130 N BLOODWORTH STREET

OAKWOOD HISTORIC DISTRICT (HOD-G)

APPLICATION FOR A CERTIFICATE OF APPROPRIATENESS – STAFF REPORT

064-17-CA 130 N BLOODWORTH STREET
Applicant: CHRISTIAN OLMSTEAD, OLMSTEAD HOMESTEADS, INC
Received: 3/31/2017 Meeting Date(s):
Submission date + 90 days: 6/29/2017 1) 5/25/2017 2) 3)

[FLOOR PLAN FOR REAR DECK]

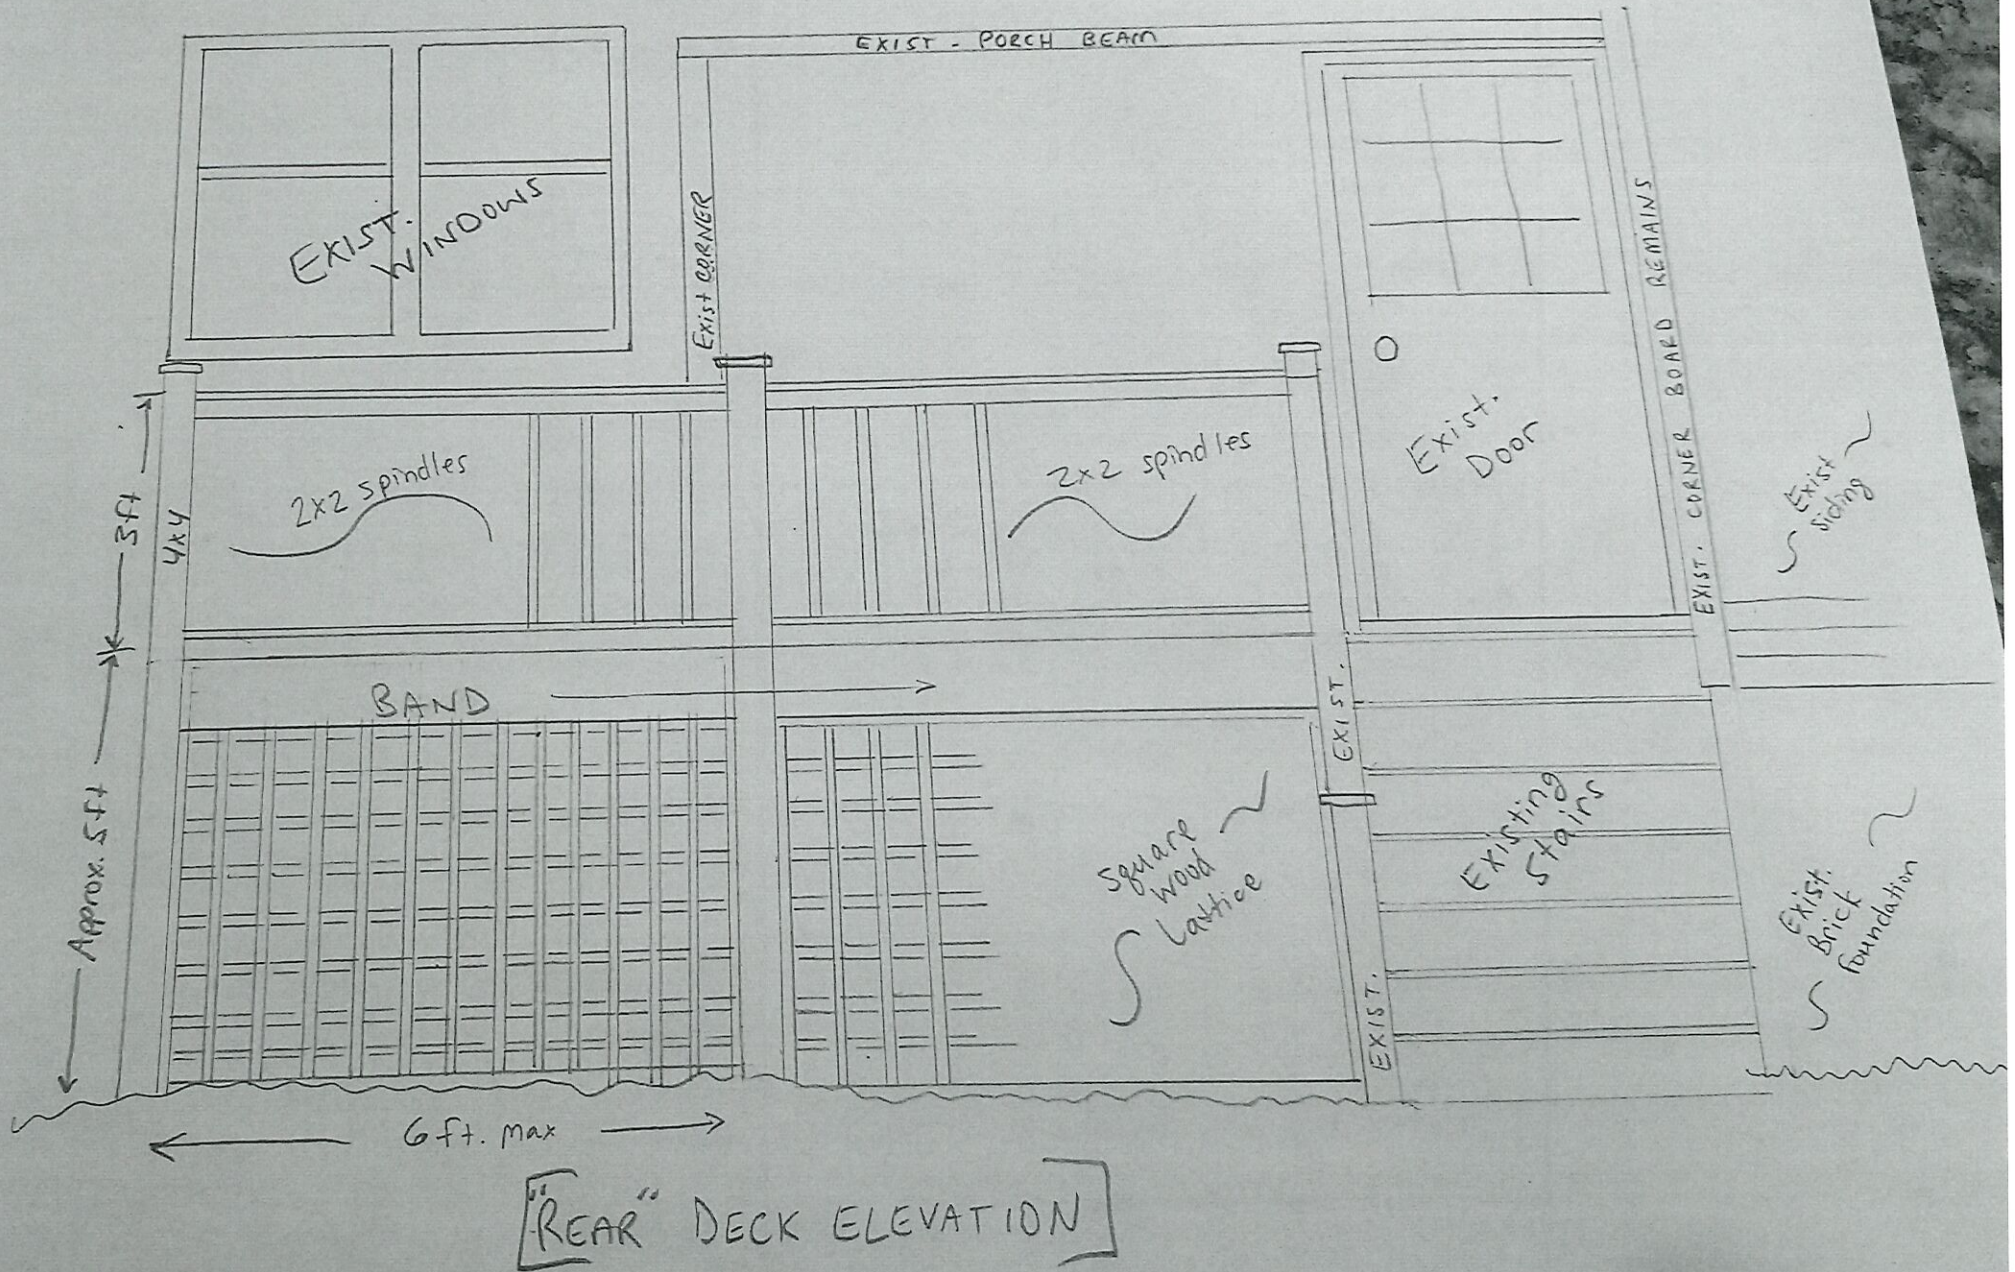
- 1* The existing porch decking offers a small landing space that is tight up against the house, serving a utilitarian purpose. It measures 3'0" x 10'6". The applicant proposes to expand the decking area to provide outdoor leisure space. The new deck is to measure 8'0" x 17'0".
- 2* A wood lattice is proposed for the underside of the east (rear) porch decking.
